Parliamentary Standing Committee on Public Works

REPORT

132kV SUBTRANSMISSION DEVELOPMENT, EAST TUGGERANONG, A.C.T.

(Tenth Report of 1986)

**GILMORE ZONE SUBSTATION
SITE PLAN**

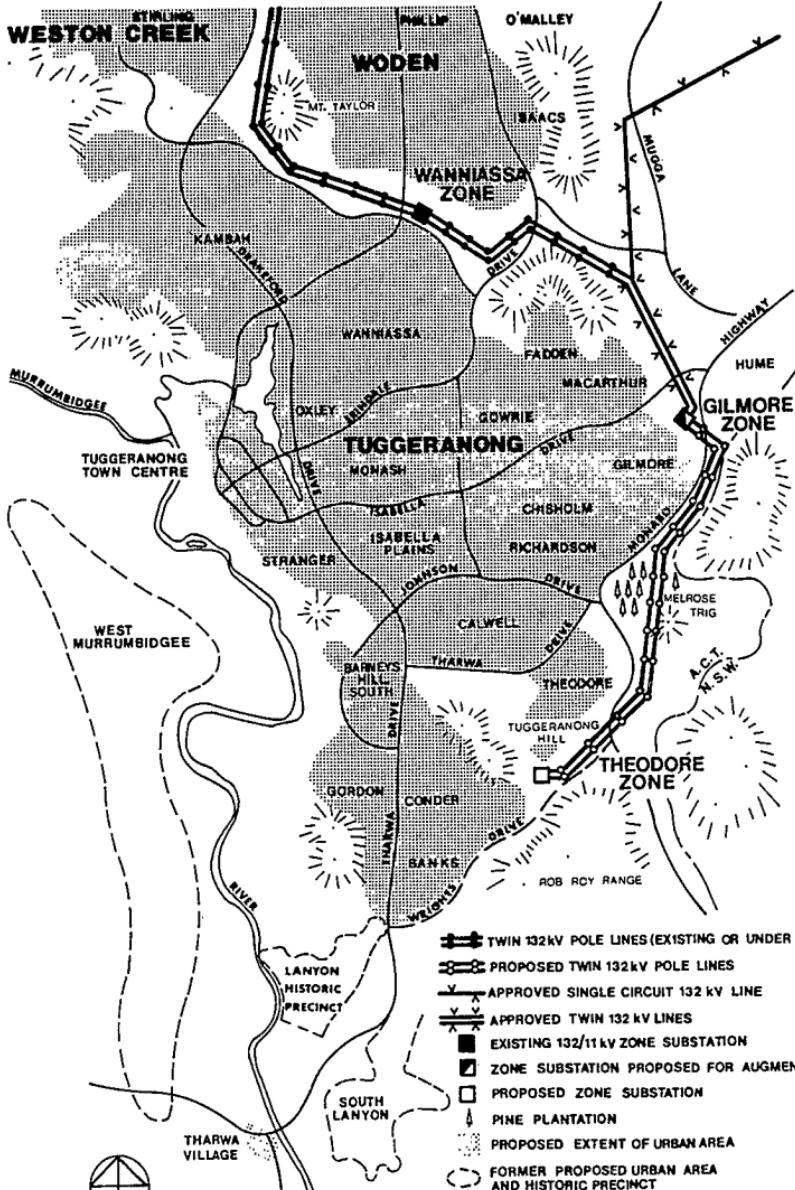
29. Space has been allocated within the existing switchyard for the additional switchgear required for the connection of the proposed lines which will be similar to that existing. Appendix B (Illustration B-2) shows the extent of work included in the present and previous submissions. Some minor associated work will also be needed in the existing substation building and yard.

ALTERNATIVES TO THE PROPOSAL

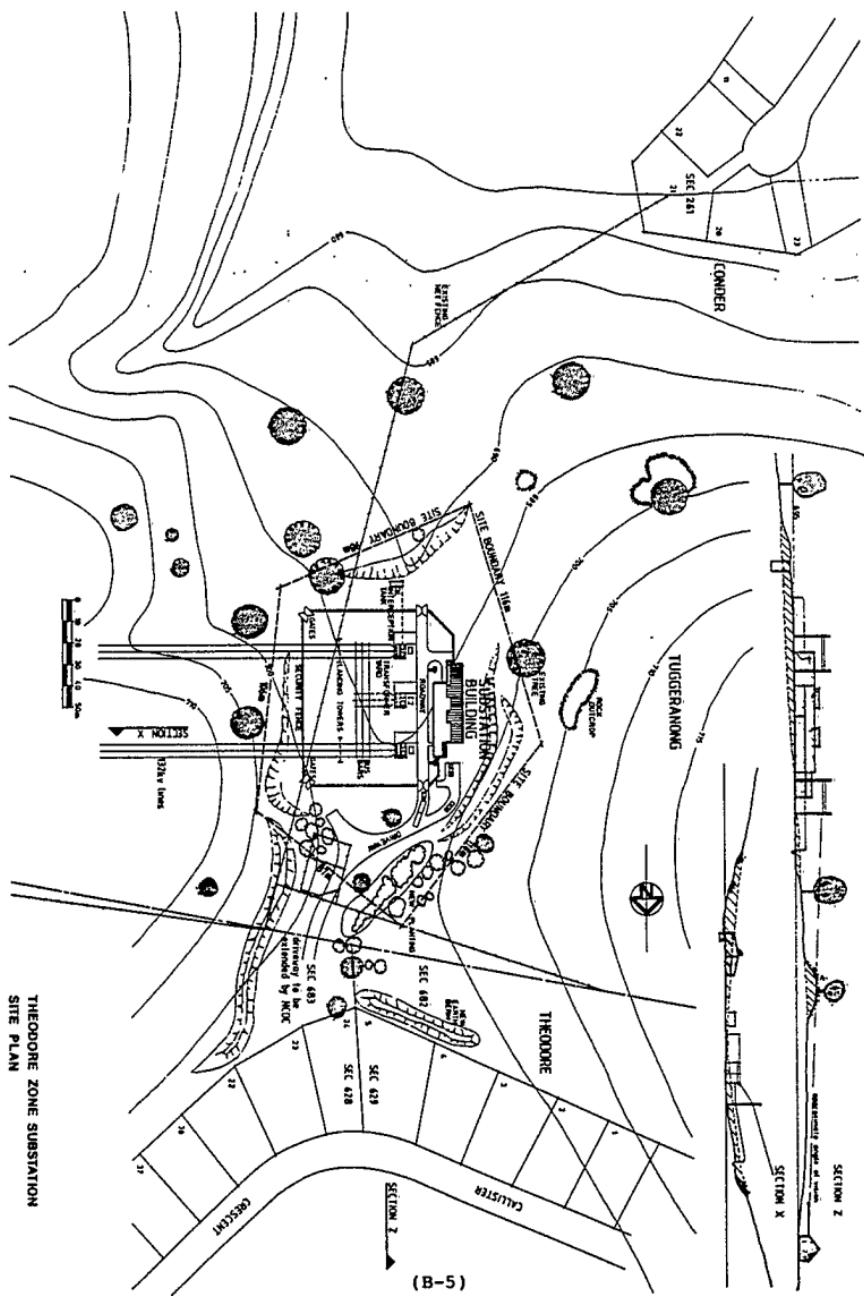
30. Alternative Routes A wide range of alternative line routes was examined by the ACTEA, the NCDC and their consultants over a 4-year period. These alternatives are shown at Appendix B (Illustration B-4).

35. Most urban line routes considered were restricted to single line use and were rejected due to their visual impact on the area. They would traverse urban areas of Tuggeranong which are currently being developed or are built-up. The routes investigated were as follows:

- from Gilmore substation along the Monaro Highway and then along Tharwa Drive. Although moderately suitable, as adjacent vegetation reduces the visual impact of the line, this alignment proposal was rejected as inappropriate for the substation site chosen.
- from Gilmore substation, along the Monaro Highway and then along the southern slopes of the high ridge south of the suburb of Theodore. The last section of this route would be on steep terrain and would be difficult to screen from the future suburb of Conder.
